# Access Audit Site Report

**McKinney Falls State Park**  
**5808 McKinney Falls Pkwy**  
**Austin, TX 78744**  
**Accessibility Evaluation**  
**Inspection Date: 11/11/2021**  
**Inspectors: Tanya Scheibe**

Prepared By  
**WT Group**

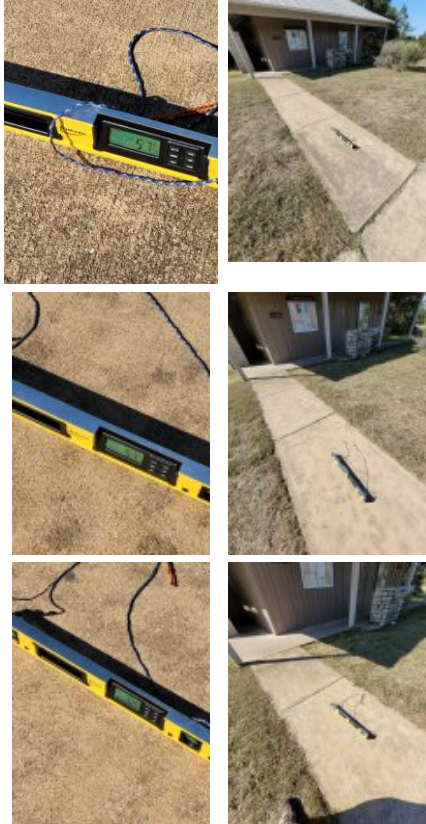
Finding Number	Area Description	Lat/Long	Finding	As Built	Recommendation	Citation	Photos	Figure
9	Exterior: Exterior Accessible Route	[30.1787073 , -97.72395 33], [30.1786827 , -97.723868 2]	The walkway contains abrupt vertical edges and/or variations over a 1/4 inch. 1/4 inch is the maximum vertical rise. Changes in level between 1/4 inch and 1/2 inch must be beveled at 1:2 or less. Changes in level greater than 1/2 inch must be by way of a ramp.	Little oak RR building - 1" CIL at covered entry to RR, 1" CIL past tree on path	Repair, bevel or ramp CIL along AR	2012 TAS Section: 303.2, 303.3  2010 ADAS Section: 303.2, 303.3	 	
10	Exterior: Headquarters Parking	[30.1808985 , -97.722171]	The cross slopes (narrow dimension) and/or running slopes (long dimension) of the access aisle exceeds 2%. The running slope and the cross slope in an accessible parking stall and the access aisle must not exceed 2%.	3.4% cross slope along parking space	Repair or correct slope of parking space and access aisle to max 2.08% in any direction	2015 ABAAS Section: 502.4  2012 TAS Section: 502.4  2010 ADAS Section: 502.4

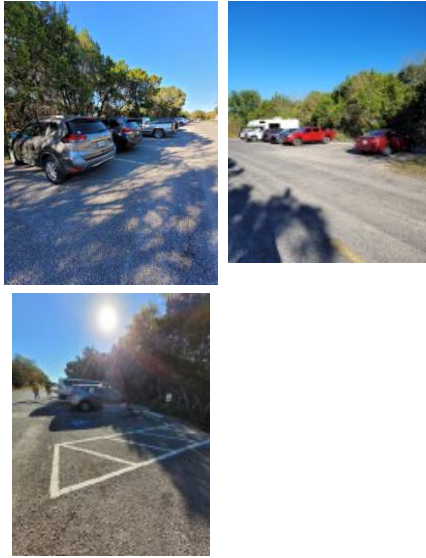
Finding Number	Area Description	Lat/Long	Finding	As Built	Recommendation	Citation	Photos	Figure
62	Exterior: Upper Falls Parking	[30.1837929 , -97.725784 6]	There are no accessible parking stalls. Each lot where parking is provided for the public as clients, guests or employees, shall provide accessible parking and shall be located on the shortest accessible route of travel from adjacent parking to an accessible entrance. There are a total of (75) parking stalls in the parking lot that could be reasonably associated with this facility. There should be a minimum of (3) accessible stalls with a minimum of (1) being designed as van accessible.	1 accessible space, 75 standard spaces	Create two or more 8' accessible parking stalls, with one 5' adjacent access aisle, with proper signage and striping based on the total number of stalls	2015 ABAAS Section: F208.2  2012 TAS Section: 208.2  2010 ADAS Section: 208.2

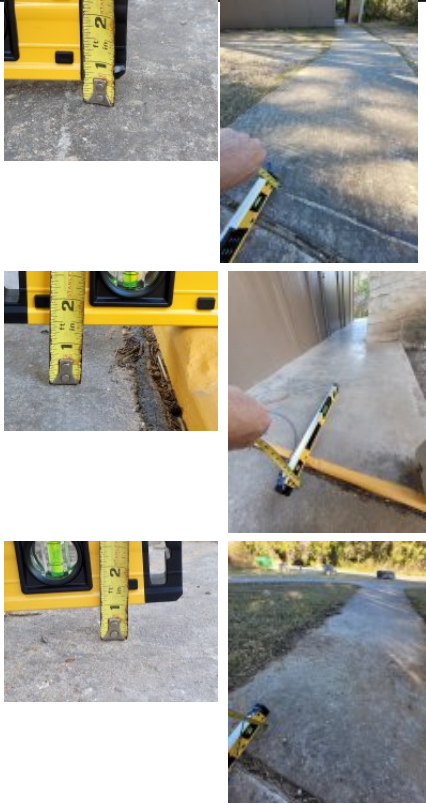
Finding Number	Area Description	Lat/Long	Finding	As Built	Recommendation	Citation	Photos	Figure
84	Exterior: Picnic Area Parking	[30.1828723 , -97.7233044]	The accessible route contains loose gravel and/or surfaces that do not provide for a stable, firm slip resistant surface.	Loose gravel on route	Resurface AR where deterioration occurs	2015 ABAAS Section: 302.1  2012 TAS Section: 302.1  2010 ADAS Section: 302.1		
85	Exterior: Picnic Area Parking	[30.18076, -97.722]	Element meets all standards and requirements	Parking near playground picnic area restroom meets scoping requirements - 14 standard, 1 accessible	None	2010 ADAS Section: N/A

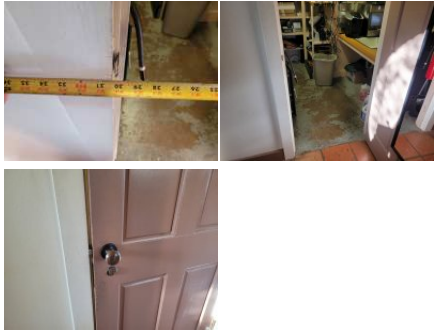
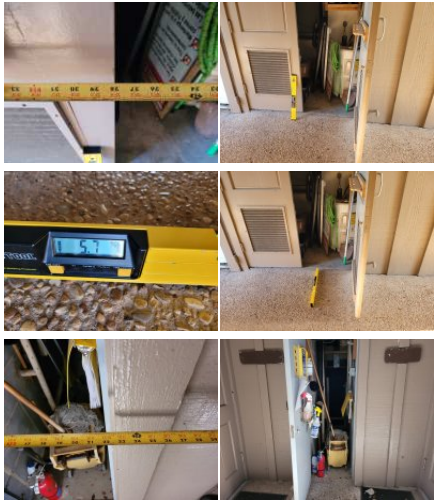
91	Exterior: Lower Falls Restroom Parking	[30.1850058, -97.7221331], [30.1851025, -97.7221941]	Changes in level greater than ½ inch (13 mm) high shall be ramped, and shall comply with 405 or 406.	Changes in Level: two at .75", two at .5", 1.5", and 1"	Repair, bevel, or ramp CIL along AR	2015 ABAAS Section: 303.4 2012 TAS Section: 303.4 2010 ADAS Section: 303.4

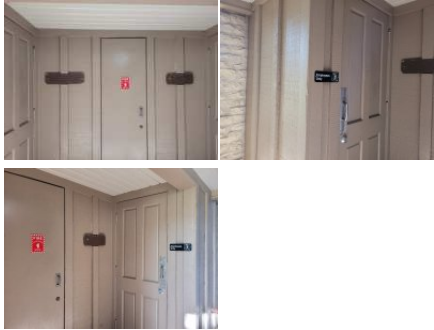
107	Headquarters: Headquarters Building	[30.1808346 , -97.721911 5]	Spaces and elements within employee work areas shall only be required to comply with 206.2.8, 207.1, and 215.3 and shall be designed and constructed so that individuals with disabilities can approach, enter, and exit the employee work area. Employee work areas, or portions of employee work areas, other than raised courtroom stations, that are less than 300 square feet (28 m2) and elevated 7 inches (180 mm) or more above the finish floor or ground where the elevation is essential to the function of the space shall not be required to comply with these requirements or to be on an accessible route.	29" wide door	For employee spaces, relocate storage, furniture, and other obstacles at doorways to provide approach, enter and exit at the employee space.	2015 ABAAS Section: F203.9  2012 TAS Section: 203.9  2010 ADAS Section: 203.9

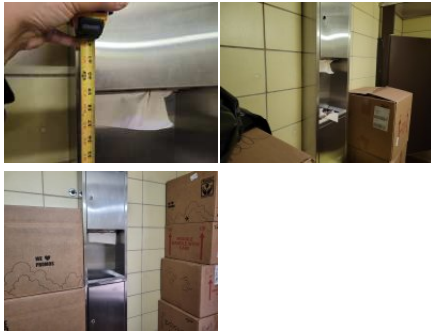
110	Headquarters: Headquarters Building	[30.1807993 , -97.722016 1]	Openings in floor or ground surfaces shall not allow passage of a sphere more than 1/2 inch (13 mm) diameter except as allowed in 407.4.3, 409.4.3, 410.4, 810.5.3 and 810.10. Elongated openings shall be placed so that the long dimension is perpendicular to the dominant direction of travel.	1" to 1.5" gaps	Fill and maintain gaps to max .5"	2015 ABAAS Section: 302.3  2012 TAS Section: 302.3  2010 ADAS Section: 302.3

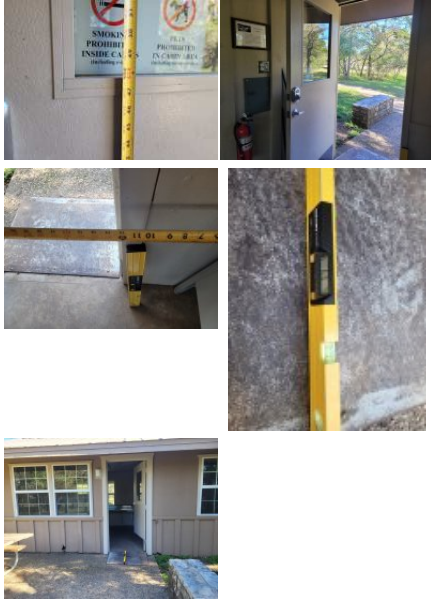
Finding Number	Area Description	Lat/Long	Finding	As Built	Recommendation	Citation	Photos	Figure
122	Headquarters: Headquarters Staff Restrooms	[30.18076, -97.722]	The faucet controls require twisting of the wrist. Faucet controls and operating mechanisms shall be operable with one hand and shall not require tight grasping, pinching or twisting of the wrist. The force required to activate controls shall be no greater than 5 lb. Lever-operated, push-type and electronically controlled mechanisms are examples of acceptable designs. Self-closing valves are allowed if the faucet remains open for at least 10 seconds.	One sink has knobs	Replace faucet controls with lever controls	2015 ABAAS Section: 606.4  2012 TAS Section: 606.4  2010 ADAS Section: 606.4		
123	Headquarters: Headquarters Staff Restrooms	[30.18076, -97.722]	Where a high forward reach is over an obstruction, the clear floor space shall extend beneath the element for a distance not less than the required reach depth over the obstruction. The high forward reach shall be 48 inches (1220 mm) maximum where the reach depth is 20 inches (510 mm) maximum. Where the reach depth exceeds 20 inches (510 mm), the high forward reach shall be 44 inches (1120 mm) maximum and the reach depth shall be 25 inches (635 mm) maximum. Where a clear floor or ground space allows a parallel approach to an element and the high side reach is over an obstruction, the height of the obstruction shall be 34 inches (865 mm) maximum and the depth of the obstruction shall be 24 inches (610 mm) maximum. The high side reach shall be 48 inches (1220 mm) maximum for a reach depth of 10 inches (255 mm) maximum. Where the reach depth exceeds 10 inches (255 mm), the high side reach shall be 46 inches (1170 mm) maximum for a reach depth of 24 inches (610 mm) maximum.	Paper towels 59" AFF	Lower operating mechanisms in restroom to max 48" AFF to highest operable part.	2015 ABAAS Section: 308.2.1, 308.3.2  2012 TAS Section: 308.2.1, 308.3.2  2010 ADAS Section: 308.2.1, 308.3.2

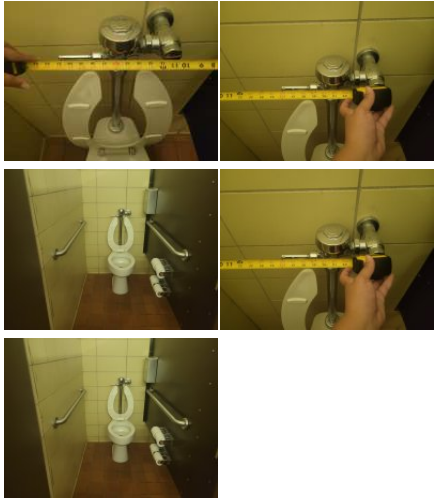
147	Cabin Area: Cabin Area Men's Restroom	[30.1783476 , -97.728973 7]	The bowl of the urinal does not extend out from the wall far enough. Urinals must project a minimum of 13-1/2 inches measured from the outer face of the urinal rim to the back of the fixture and be a maximum of 17 inches above the floor.	12 inch urinal depth	Replace urinal with one having a 13.5" min depth mounted at max 17" to rim with flush controls max 48" AFF	2015 ABAAS Section: 605.2  2012 TAS Section: 605.2  2010 ADAS Section: 605.2

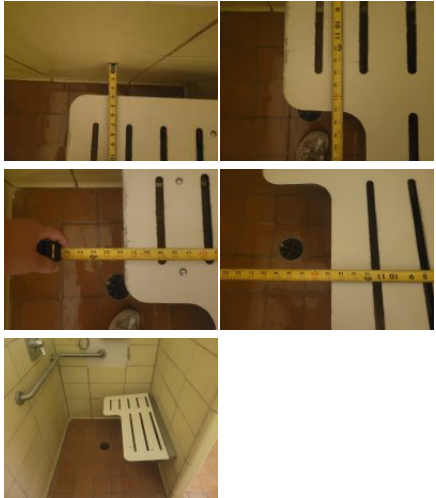
169	Cabin Area: Cabin Area Men's Shower	[30.1783356 , -97.728973 7]	The force required to operate the element exceeds the maximum. The force required to activate operable parts is 5 pounds maximum.	12# force required at fixed shower head	Adjust operating mechanism to be usable with 5 #f or less	2015 ABAAS Section: 309.4  2012 TAS Section: 309.4  2010 ADAS Section: 309.4

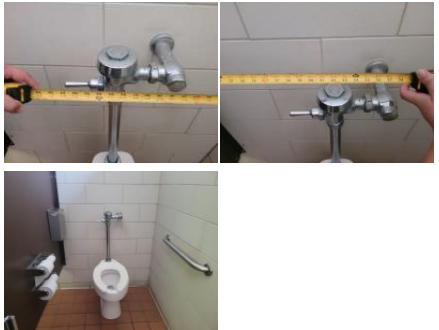
221	Grapevine Loop Camping Area: Grapevine Loop Camping Men's Restroom	[30.1770677 , -97.726241 9]	The toilet paper is not installed within the compliant range in front of the toilet. Toilet paper dispensers shall be 7 inches minimum and 9 inches maximum in front of the water closet measured to the centerline of the dispenser. The outlet of the dispenser shall be 15 inches minimum and 48 inches maximum above the finish floor and shall not be located behind grab bars. Dispensers shall not be of a type that controls delivery or that does not allow continuous paper flow. There shall be a clearance of 1 1/2 inches minimum below the grab bar.	2" from edge of toilet to centerline of TP	Remount toilet paper dispenser max 7" to 9" from front of toilet, 15" to 48" AFF and min 12" above or 1.5" below grab bar	2015 ABAAS Section: 604.7  2012 TAS Section: 604.7  2010 ADAS Section: 604.7		
222	Grapevine Loop Camping Area: Grapevine Loop Camping Men's Restroom	[30.1770668 , -97.726233 9]	The sink projects more than 4 inches into the circulation path. Wall-mounted objects that have leading edges between 27 inches and 80 inches from the floor must not project more than 4 inches into the circulation path. Protruding objects that extend to the floor or within 27 inches of the floor are cane detectable and are therefore not hazardous. Where it is necessary or desirable to have objects protrude from the wall, a manner of cane detection must be provided.	Sinks projects into route	Relocate protruding objects or place cane detectable warning or bollard at foot of item	2015 ABAAS Section: 307.2  2012 TAS Section: 307.2  2010 ADAS Section: 307.2

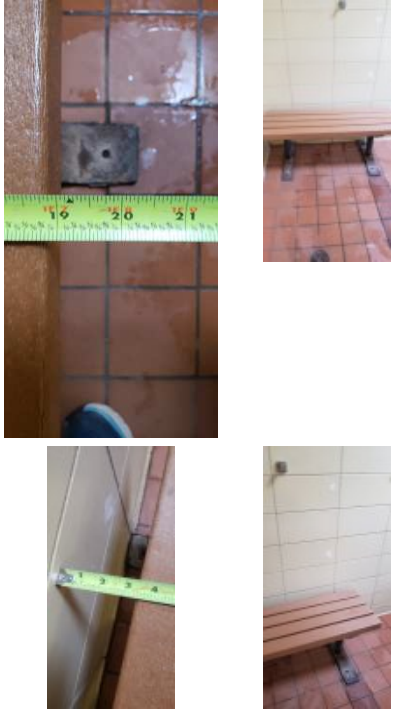
241	Grapevine Loop Camping Area: Grapevine Loop Camping Area Women's Shower	[30.1770557 , -97.726237 9]	The bench is not deep enough or long enough or is missing. Benches shall be provided having seats that are 42 inches long minimum and 20 inches deep minimum and 24 inches deep maximum. The bench shall provide for back support or shall be affixed to a wall. Back support shall be 42 inches (1065 mm) long minimum and shall extend from a point 2 inches (51 mm) maximum above the seat surface to a point 18 inches (455 mm) minimum above the seat surface. Back support shall be 2½ inches (64 mm) maximum from the rear edge of the seat measured horizontally. The top of the bench seat surface shall be 17 inches (430 mm) minimum and 19 inches (485 mm) maximum above the finish floor or ground.	Small benches only	Replace bench in dressing area with one having a seat depth of 20" to 24" deep, 42" long, affixed to the wall or having a back and mounted 17" to 19" AFF	2012 TAS Section: 903.4, 903.2, 903.3, 903.5  2010 ADAS Section: 903.4, 903.2, 903.3, 903.5

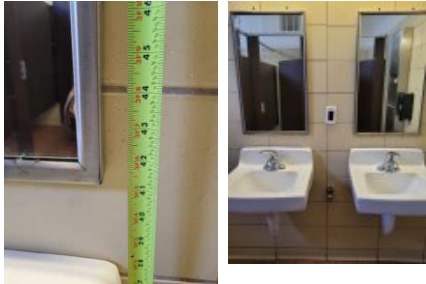
Finding Number	Area Description	Lat/Long	Finding	As Built	Recommendation	Citation	Photos	Figure
242	Grapevine Loop Camping Area: Grapevine Loop Camping Area Women's Shower	[30.1770543 , -97.726240 6]	There are no accessible bathing or shower facilities. Where facilities for bathing are provided for the public, clients or employees, including showers or bathtubs, at least one shower or bathtub and support facilities such as lockers, and not less than 1 percent of all facilities, shall be accessible.	Lacks accessible shower	Create an accessible shower in locker/bathing room	2015 ABAAS Section: F213.3.6  2012 TAS Section: 213.3.6  2010 ADAS Section: 213.3.6

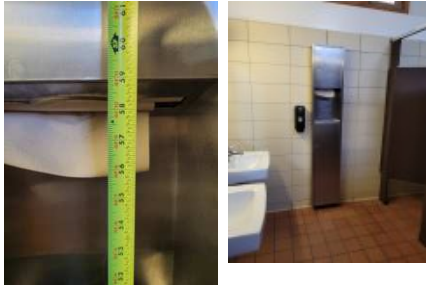
Finding Number	Area Description	Lat/Long	Finding	As Built	Recommendation	Citation	Photos	Figure
243	Little Oak Camping Area: Little Oak Camping Area Men's Restroom	[30.1787836 , -97.723976 8]	The shower seat does not have a compliant space between it and the wall. The folding seat must be mounted 17-19 inches above the floor, and have a maximum space of 1-1/2 inches between the edge of the seat and the side wall and 2-1/2 inches maximum to the seat wall.	Seat 16" wide per section	Remount shower seat to the correct location and height in the shower. Cost for compliant seat included in separate finding	2015 ABAAS Section: 610.3.2  2012 TAS Section: 610.3.2  2010 ADAS Section: 610.3.2		
244	Little Oak Camping Area: Little Oak Camping Area Men's Restroom	[30.1787794 , -97.723971 4]	Where a seat is provided in a standard roll-in shower compartment, it shall be a folding type, shall be installed on the side wall adjacent to the controls, and shall extend from the back wall to a point within 3 inches (75 mm) of the compartment entry. Where a seat is provided in an alternate roll-in type shower compartment, it shall be a folding type, shall be installed on the front wall opposite the back wall, and shall extend from the adjacent side wall to a point within 3 inches (75 mm) of the compartment entry. In transfer-type showers, the seat shall extend from the back wall to a point within 3 inches (75 mm) of the compartment entry. The top of the seat shall be 17 inches (430 mm) minimum and 19 inches (485 mm) maximum above the bathroom finish floor. Seats shall comply with 610.3.1 or 610.3.2.	Seat 11" from edge	Provide the correct seat based on shower type.	2015 ABAAS Section: 610.3  2012 TAS Section: 610.3  2010 ADAS Section: 610.3

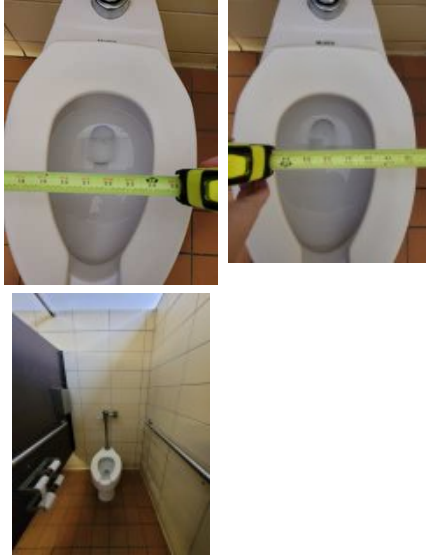
248	Little Oak Camping Area: Little Oak Camping Area Men's Restroom	[30.1787834 , -97.723971 4]	Shower controls are in the incorrect location In transfer type shower compartments, the controls, faucets, and shower spray unit shall be installed on the side wall opposite the seat 38 inches (965 mm) minimum and 48 inches (1220 mm) maximum above the shower floor and shall be located on the control wall 15 inches (380 mm) maximum from the centerline of the seat toward the shower opening.	Controls 24.5" from opening	Remount shower controls to the correct location in the transfer shower	2015 ABAAS Section: 608.5.1  2012 TAS Section: 608.5.1  2010 ADAS Section: 608.5.1

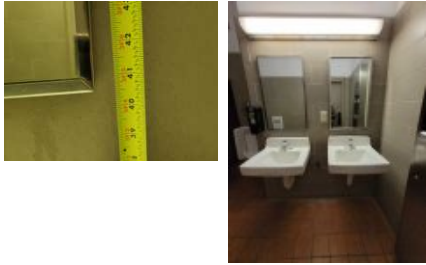
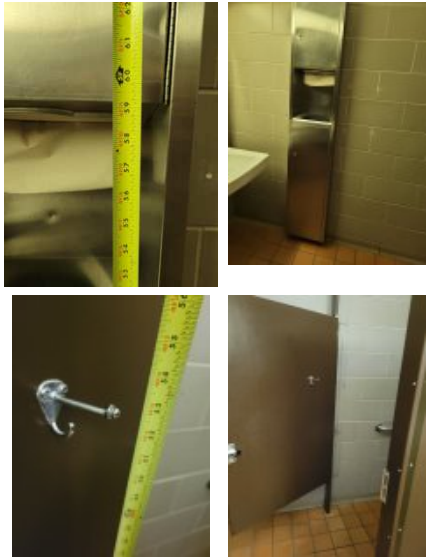
263	Little Oak Camping Area: Little Oak Camping Area Women's Restroom	[30.1787982, -97.723966 1]	Transfer type shower compartments shall be 36 inches (915 mm) by 36 inches (915 mm) clear inside dimensions measured at the center points of opposing sides and shall have a 36 inch (915 mm) wide minimum entry on the face of the shower compartment. Clearance of 36 inches (915 mm) wide minimum by 48 inches (1220 mm) long minimum measured from the control wall shall be provided.	48" depth, by 36" wide	Reduce transfer shower to compliant 36" by 36" clear inside dimension	2015 ABAAS Section: 608.2.1  2012 TAS Section: 608.2.1  2010 ADAS Section: 608.2.1

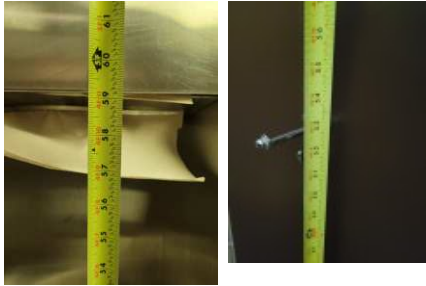
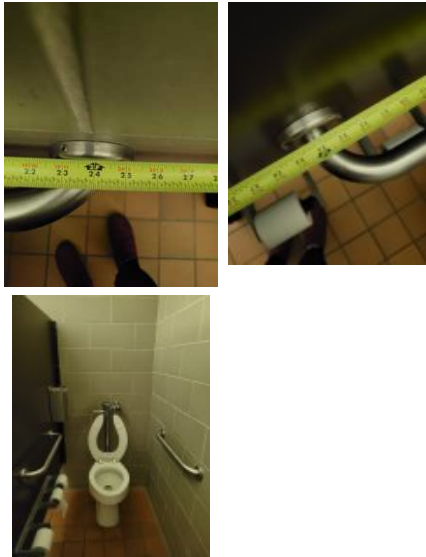
Finding Number	Area Description	Lat/Long	Finding	As Built	Recommendation	Citation	Photos	Figure
275	Big Oak Camping Area: Big Oak Camping Area Men's Restroom	[30.1801363 , -97.724661 5]	The mirror is mounted too high. Mirrors must have the bottom edge of the reflecting surface a maximum of 40 inches above the floor if above a sink or counter. Mirrors not located above lavatories or countertops shall be installed with the bottom edge of the reflecting surface 35 inches maximum above the finish floor or ground.	Mirror mounted 41" AFF	Lower mirror so reflective surface is max 40" AFF	2015 ABAAS Section: 603.3  2012 TAS Section: 603.3  2010 ADAS Section: 603.3		
276	Big Oak Camping Area: Big Oak Camping Area Men's Restroom	[30.1801438 , -97.724674 4]	Where a high forward reach is over an obstruction, the clear floor space shall extend beneath the element for a distance not less than the required reach depth over the obstruction. The high forward reach shall be 48 inches (1220 mm) maximum where the reach depth is 20 inches (510 mm) maximum. Where the reach depth exceeds 20 inches (510 mm), the high forward reach shall be 44 inches (1120 mm) maximum and the reach depth shall be 25 inches (635 mm) maximum. Where a clear floor or ground space allows a parallel approach to an element and the high side reach is over an obstruction, the height of the obstruction shall be 34 inches (865 mm) maximum and the depth of the obstruction shall be 24 inches (610 mm) maximum. The high side reach shall be 48 inches (1220 mm) maximum for a reach depth of 10 inches (255 mm) maximum. Where the reach depth exceeds 10 inches (255 mm), the high side reach shall be 46 inches (1170 mm) maximum for a reach depth of 24 inches (610 mm) maximum.	Paper towels 56" AFF, hook in stall 52" AFF	Lower hook to max 48" above the finished floor (AFF) to highest operable part. Lower dispenser to max 46" above the finished floor (AFF) for a side reach over counter.	2015 ABAAS Section: 308.2.1, 308.3.2  2012 TAS Section: 308.2.1, 308.3.2  2010 ADAS Section: 308.2.1, 308.3.2

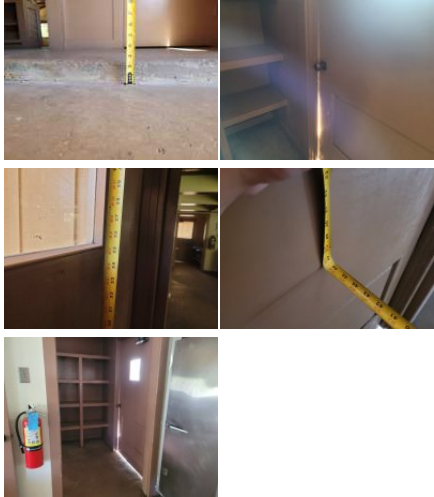
Finding Number	Area Description	Lat/Long	Finding	As Built	Recommendation	Citation	Photos	Figure
294	Big Oak Camping Area: Big Oak Campsites	[30.1804261 , -97.724401 2]	Fire building surfaces shall be 9 inches (230 mm) minimum above the ground	Fire building surface at ground level	Correct fire building surface to be 9" min above the ground as a smart practice.	2015 ABAAS Section: 1011.5.1		
295	Big Oak Camping Area: Big Oak Campsites	[30.180576, -97.724370 4]	Water spouts at water hydrants and water utility hook-ups shall be 28 inches (710 mm) minimum and 36 inches (915 mm) maximum above the ground	Water spigot 25" AFF	Remount water spouts to 28" min or 36" max above the ground as a smart practice	2015 ABAAS Section: 1011.6		
296	Big Oak Camping Area: Big Oak Campsites	[30.1805465 , -97.724366 4]	Parking spaces and pull-up spaces for recreational vehicles shall be 20 feet (6100 mm) wide minimum. EXCEPTION: Where two adjacent parking spaces are provided for recreational vehicles, one parking space shall be permitted to be 16 feet (4880 mm) wide minimum.	RV parking stall - 12' 8" width	Correct RV parking space to be 20' wide minimum; or 16' for two adjacent spaces as a smart practice.	2015 ABAAS Section: 1012.2, 1012.2 EXCEPTION

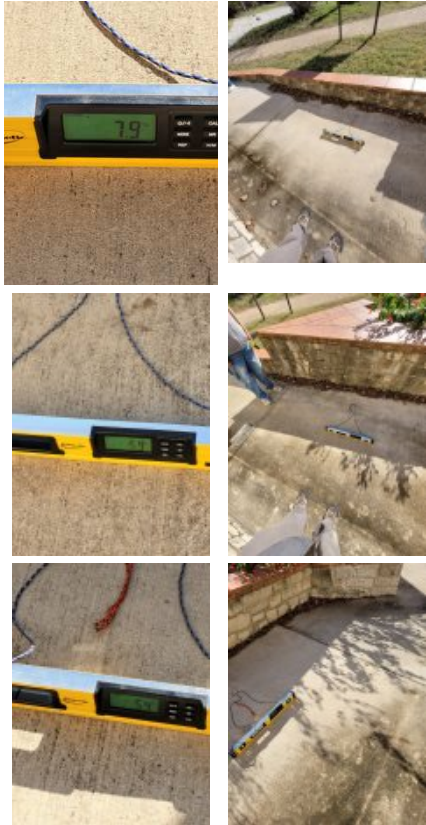
349	Park Sites: Park Elements	[30.1805315 , -97.725827 5]	The surface of the clear ground space shall be firm and stable The slope of the clear ground space surface shall not be steeper than 1:48 in any direction. EXCEPTION: Where the surface is other than asphalt, concrete, or boards, slopes not steeper than 1:20 shall be permitted when necessary for drainage	Dump station at little and big oak camping - 3% slope in CFS	Correct surface at water spigot to firm, stable and having max slope of 2.08% or 5% if other than concrete asphalt or boards as a smart practice	2015 ABAAS Section: 1011.2.2, 1011.2.3, 1011.2 EXCEPTION		
350	Park Sites: Park Elements	[30.1842888 , -97.725702 8]	There is no accessible route to the site elements At least one accessible route shall connect accessible buildings, accessible facilities, accessible elements, and accessible spaces that are on the same site.	No AR to sign, safety equipment or recycling by Upper Falls look-out	Create an accessible route with crushed stone or other outdoor material from parking or walkway to site elements	2015 ABAAS Section: F206.2.2  2012 TAS Section: 206.2.2  2010 ADAS Section: 206.2.2

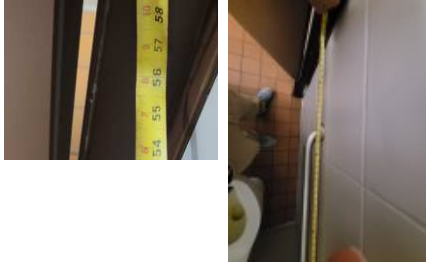
387	Upper Falls: Upper Falls Men's Restroom	[30.1835381 , -97.727332 2]	The accessible route contains running slopes greater than 5 percent and cross slopes greater than 2 percent across the width of the walk and has not been constructed as a ramp (i.e. handrails, wheel guides, etc.). When the slope in the direction of travel of any walk exceeds 1 unit vertical in 20 units horizontal (5-percent slope), it must be constructed as ramp. Surface cross slopes must not exceed one unit vertical in 48 units. Horizontal (2-percent slope).	2.6% slope	Correct or repair slope to max 5% running and 2.08% cross	2015 ABAAS Section: 403.3  2012 TAS Section: 403.3  2010 ADAS Section: 403.3

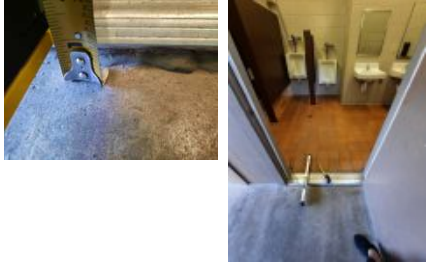
405	Picnic Area: Picnic Area Women's Restroom	[30.1829727 , -97.723349 2]	Minimum maneuvering clearances at doors and gates shall comply with 404.2.4. Maneuvering clearances shall extend the full width of the doorway and the required latch side or hinge side clearance. Maneuvering clearances shall have a max slope of 2.08%.	2.5% slope in door maneuvering clearance	For all doors along the public circulation route, correct slope in door clearance to max 2.08%.	2010 ADAS Section: 404.2.3, 404.2.7, 404.2.4, 404.2.11, 404.2.11 Exception

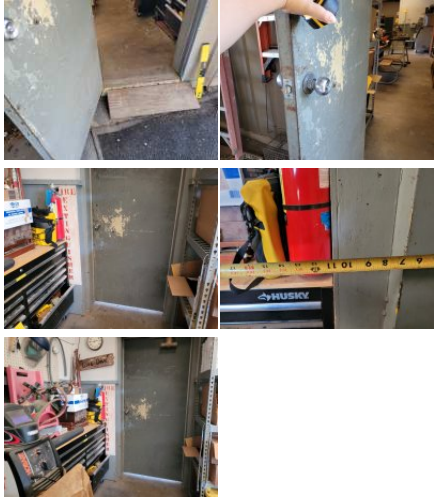
436	Homestead Trail Trailhead : Homestead Trail Trailhead	[30.1888308, -97.720417 3]	The surface of trails, passing spaces, and resting intervals shall be firm and stable	Trail lacks firm and stable surface	Replace surface of trail with one that is firm and stable as a smart practice.	2015 ABAAS Section: 1017.2

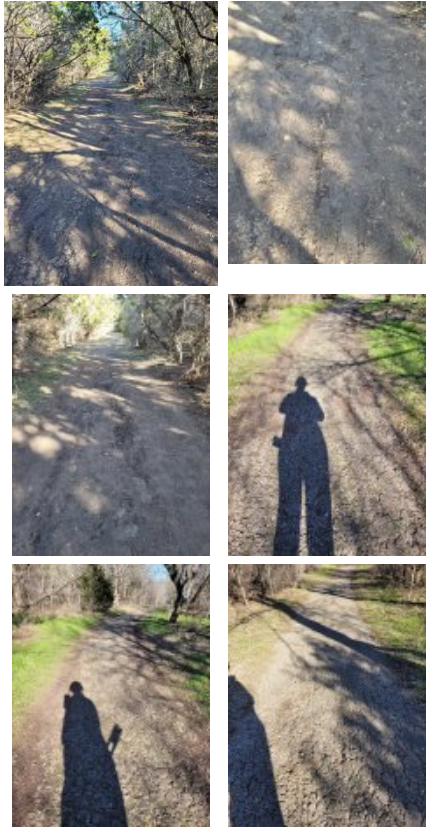
457	Trails: Trailhead	[30.1835042 , -97.72860 09], [30.1841216 , -97.727597 8]	The cross slope shall not be steeper than 1:48. EXCEPTION: Where the surface is other than concrete, asphalt, or boards, cross slopes not steeper than 1:20 shall be permitted when necessary for drainage.	Onion Creek Trail - 10.9% and 6.5% cross slope approaching woods	Correct or repair pathway cross slope to max 2.08% or 5% depending on surface as a smart practice.	2015 ABAAS Section: 1017.2
